Fullcharm Fashion Knitters Ltd.

Plot # 1175 & 1179, Bashon Sarak, Vogra, National University
(23.908870, 90.207318)

11 February 2025

Structural Inspection Report

Observation 1: Stress in the foundation exceeds the normal design limit for a partially seven-storied (G+6) structure. [Building-1]

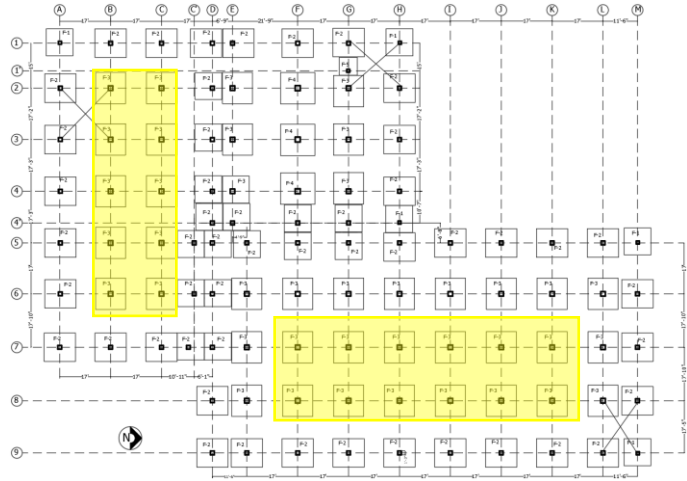
Description: The cursory calculation indicates that foundations are stressed above the normal design limit at the marked locations considering a floor live load of 3 kPa for the typical production floor and 1.5 kPa for the roof.

Action Plan: The building engineer is required to review design loads and foundation stresses. Also, produce and actively manage load management plans.

Observation 2: Flat Plate stressed above normal design limit. [Building-1]

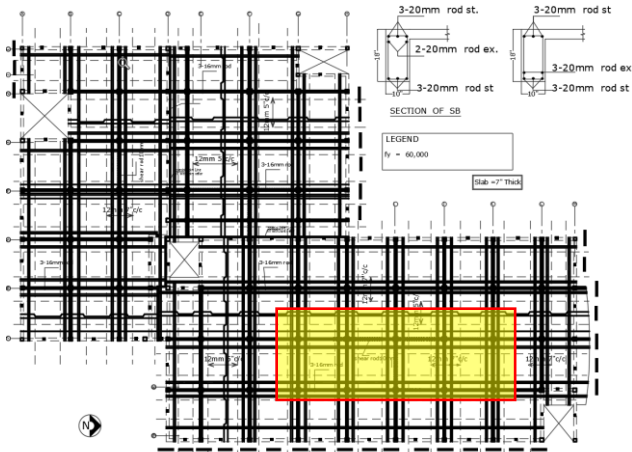
Description: Cursory calculation indicates that the stresses in the slab of the Building 1 (Part A) are above the normal design limit, considering 3 kPa floor live load, minimum concrete strength and 375x375 mm column C3 at upper floor above the 1F. Additionally, no material test report for the flat slab was found during the inspection.

Action Plan: The building engineer is required to carry out Engineering Assessment (EA) as well as suggested remedial works. The building engineer is required to confirm material strength of flat slab and incorporate the test result in EA.

Observation-5: Lack of information and discrepancy between the provided drawing and site condition. [Building-2]

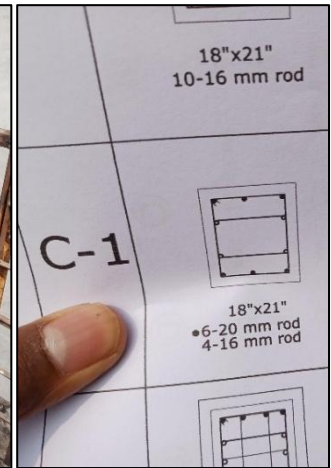
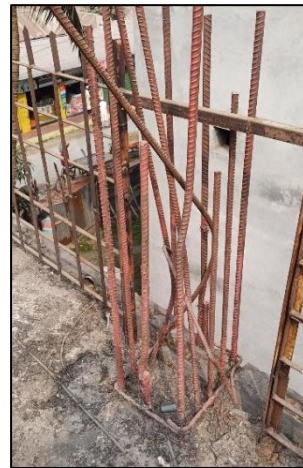
Floor and toilet built-ups were not mentioned in the drawing

Undocumented UGWR (55954 gallons)

Column C1 (grid H-5) 10Ø16 re-bar found instead of 4Ø16+6Ø20

Column C1 (grid I-7) 12 no's re-bar found instead of 10 no's

Description: During the inspection, lack of information and discrepancy was found between the provided as-built drawing and the actual site condition.

Action Plan: The building engineer is required to survey the structure and update the as-built drawing along with the design report as per the actual site condition.

Observation-6: Lack of local authority approval and future vertical extension. [Building-2]

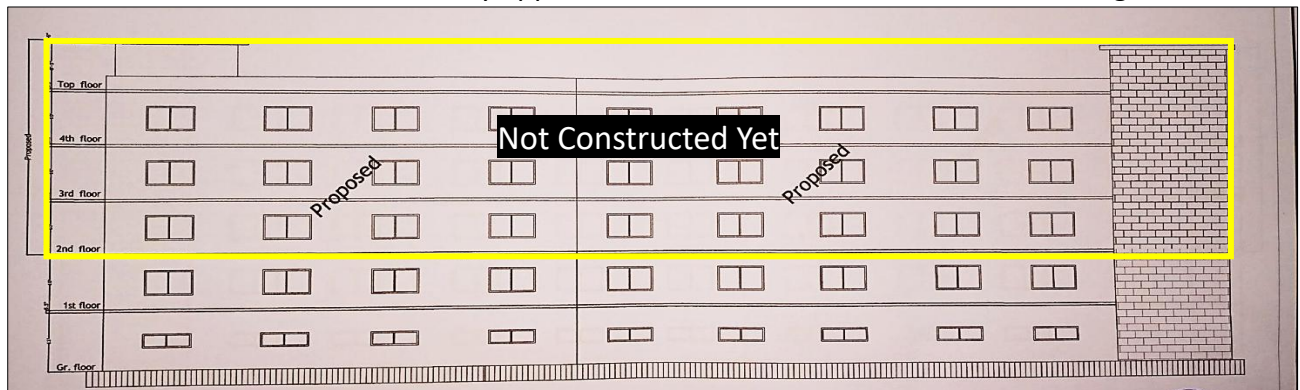
Description: The building is an existing two-storied (G+1) and proposed five-storied (G+4) reinforced concrete (RC) structure. But no local authority was available. However, the factory has a plan for future vertical extension. Projected rebar left on the roof.

Action Plan: The factory is required to collect the local authority approval. The building engineer is required to follow the construction safety measures during the commencement of further extension work.

Observation-7: Stress in the foundation exceeds the normal design limit for the proposed five-storied (G+4) structure. [Building-2]

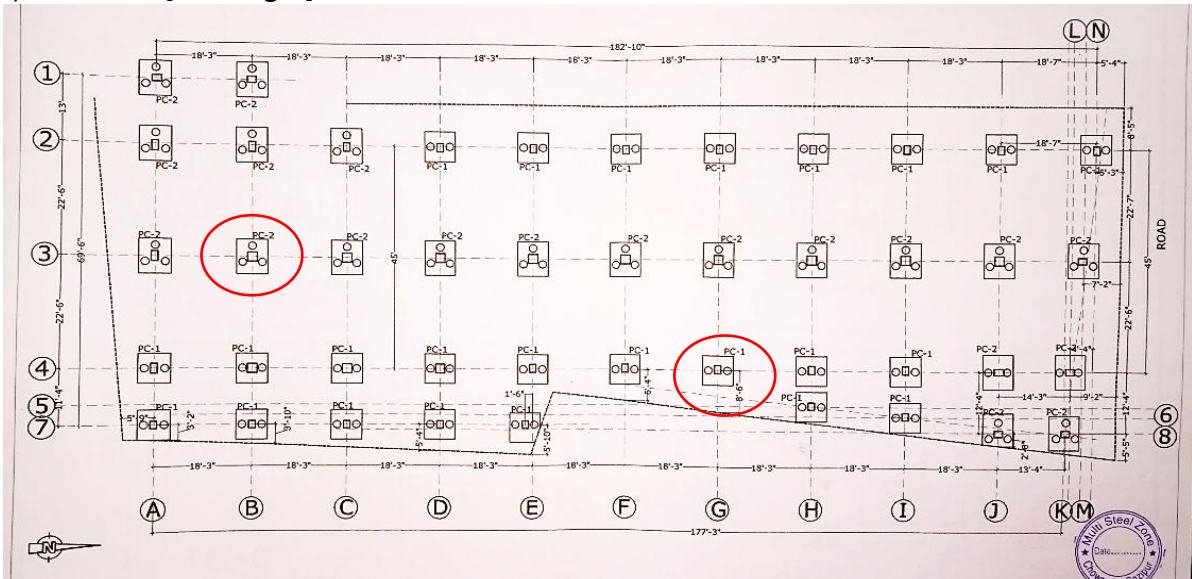
Description: The cursory calculation indicates that foundations are stressed above the normal design limit at the marked locations considering floor live load of 3 kPa for the typical production floor, 1.5 kPa for the roof, and 6 kPa for ground suspended floor storage.

Action Plan: The building engineer is required to review design loads and foundation stresses. Also, produce and actively manage load management plans.

C1 Column schedule

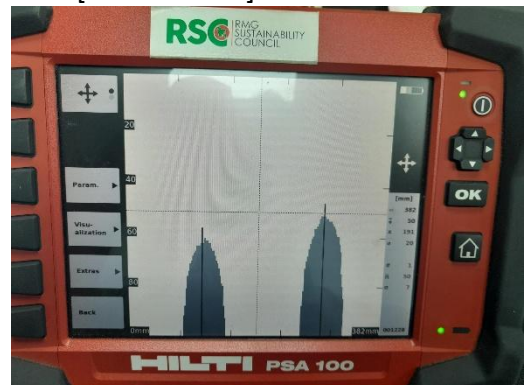
Observation 14: Mismatch between drawing & onsite condition. [Boiler Room]

Description: The amount of rebar in columns C1 did not match the drawings. In columns C1 4 nos rebars were found instead of the specified 8. Also the beam layout doesn't match onsite conditions.

Action Plan: The building engineer is required to update the drawings based on the as-constructed structure.
